***NRC - PG&E Meeting
Cask Handling Enhancements
December 4, 2007***

Diablo Canyon Power Plant
Used Fuel Storage Project

12/04/2007

Enhancement Spent Fuel Pool Frame

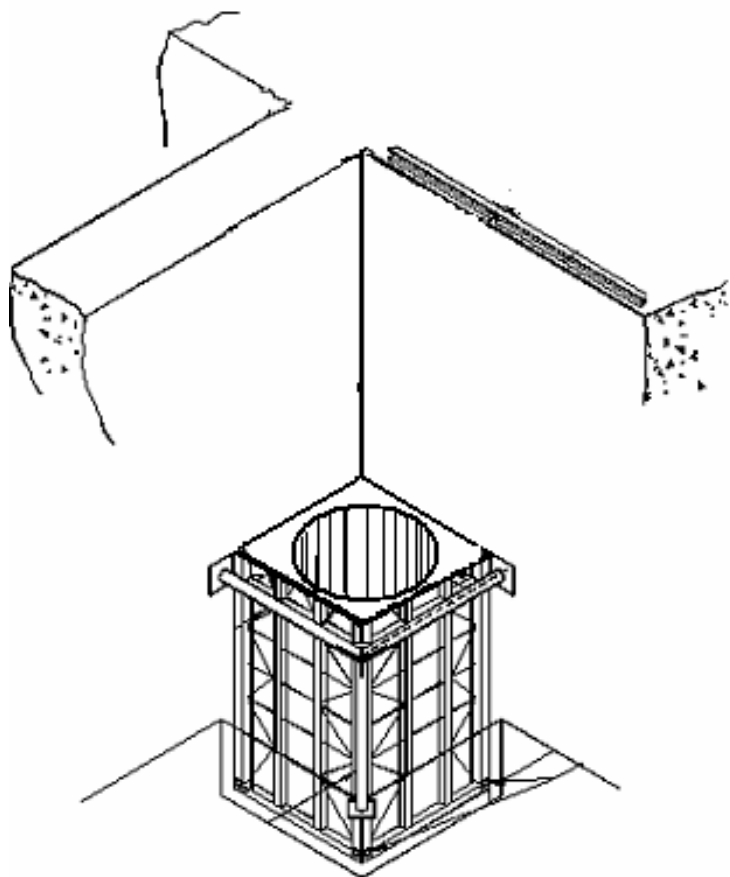
- Original Configuration
 - Frame extends from spent fuel pool cask recess area floor elevation 94'-6" to top of pool walls at elevation 141'
 - Frame relied upon to guide transfer cask and prevent interaction with pool walls during cask vertical movement coincident with a seismic event
 - Gate in frame opens for fuel movement to or from MPC

- **Current Configuration**
 - Credit S-F-P crane to eliminate postulated cask load drop accident in pool
 - Evaluate impact of cask swing into wall during a seismic event, from elevation 141' to 115'
 - Shortened SFP frame precludes adverse interaction of transfer cask with fuel storage racks below elevation 115'
 - Gate in frame structure for fuel movement no longer necessary

Enhancement Cask Washdown Area Structure

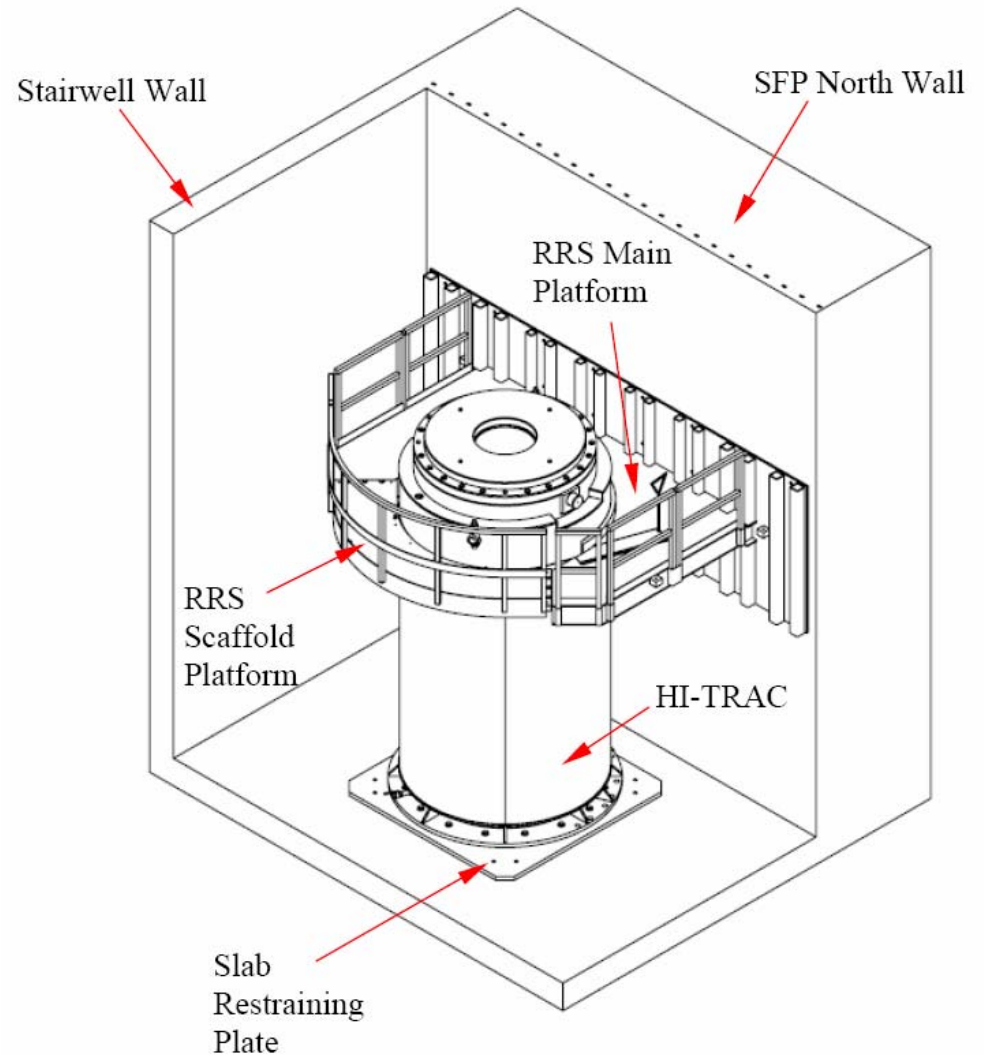
- **Current Configuration**
 - Credit S-F-P crane to eliminate postulated cask load drop accident into CWA structure
 - CWA structure functions to prevent cask-to-FHB/AB structure seismic interaction during cask and MPC processing operations
 - Relocate structure in CWA to simplify cask decon and MPC processing - ALARA
 - Remove gate feature for cask lateral access

- CWA Structure Relocation

Enhancement Vertical MPC Handling

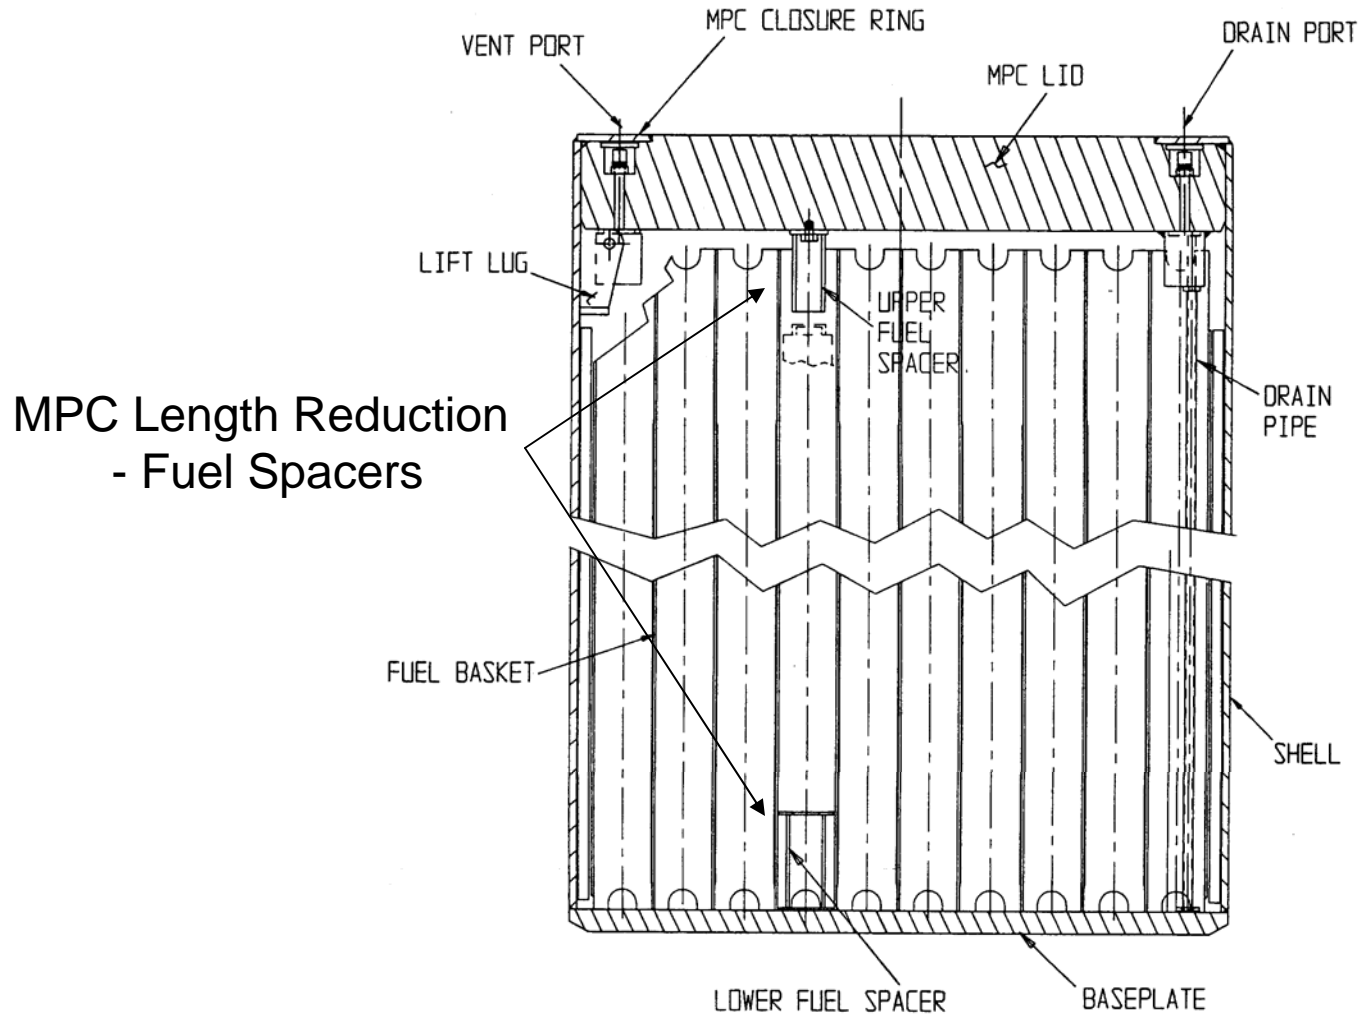
- Original Configuration
 - Holtec HI-TRAC 125D and HI-STORM 100SA MPCs
 - Loaded MPC exits/enters FHB/AB in horizontal orientation
 - Loaded MPC horizontally-transported from FHB/AB to DC ISFSI Cask Transfer Facility (CTF)

- **Current Configuration**
 - Deploy shortened (approx. 9 in.) MPC and Transfer Cask (used at Trojan ISFSI) for vertically-oriented passage into and out of the FHB/AB exterior door on a low profile dolly
 - Minor modification to FHB/AB exterior door frame to increase height and width
 - Eliminate cask transport frame (no downending/upending operations)
 - Eliminate transfer cask horizontal lift rig
